SUBJECT: NuScale Power, LLC Response to NRC Request for Additional Information No. 9172 (eRAI No. 9172) on the NuScale Topical Report, "Evaluation Methodology for Stability Analysis of the NuScale Power Module," TR-0516-49417, Revision 0

eRAI No.: 9172

NRC Question No.: 01-59

Figure 1: Diagram of the CVCS

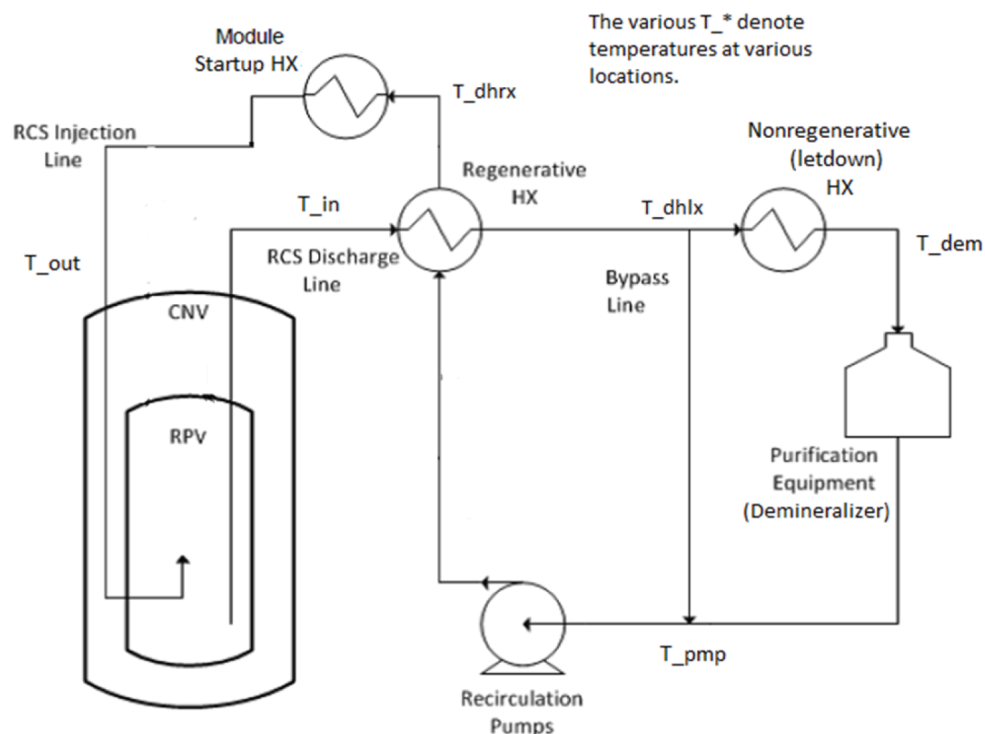
In order to make an affirmative finding associated with the above regulatory requirement important to safety, NuScale should provide a detailed description of the CVCS model in PIM that includes: a list of the components of the CVCS, a flow diagram, and equations describing how flow rates and fluid temperature are computed by PIM.

The NuScale chemical volume and control system (CVCS) is simple in design and is not required to function during or after an accident. During normal operation, the CVCS recirculates a portion of the primary coolant through demineralizers and filters to maintain primary coolant cleanliness and chemistry. A portion of the recirculated coolant is used to supply the pressurizer sprays for controlling reactor pressure. Primary system coolant inventory is controlled by injection of additional water when the primary coolant levels are low or letdown of primary coolant to the liquid radioactive waste system when coolant inventory is high. Additionally, during the module start-up process, the CVCS is used to add heat to the primary coolant via the module heatup heat exchanger to establish natural circulation flow in the primary coolant system. A diagram of the CVCS is provided in Figure 1.

Relative to Figure 1, PIM has the following simplifications regarding the CVCS.

In PIM, the CVCS is modeled by withdrawing letdown at a user-specified flow rate from a user-specified node in the downcomer at the local node conditions, passing the extracted fluid through the CVCS heat exchangers and pumps, and returning charging flow to a user-specified node in the riser. The fluid mass and energy are added to the node via calculations within PIM. No credit for the momentum transfer from the injected flow is taken that might increase the primary loop flow. Letdown flow and charging flow are each lagged by 10 seconds to represent the delaying effects of flow through long pipes.

The CVCS model in PIM is discussed more below. The variables used in the discussion below are listed in Table1, which relates the variables to locations of Figure 1. Enthalpies and temperatures are related via a state call that assumes subcooled liquid at the RCS pressure.
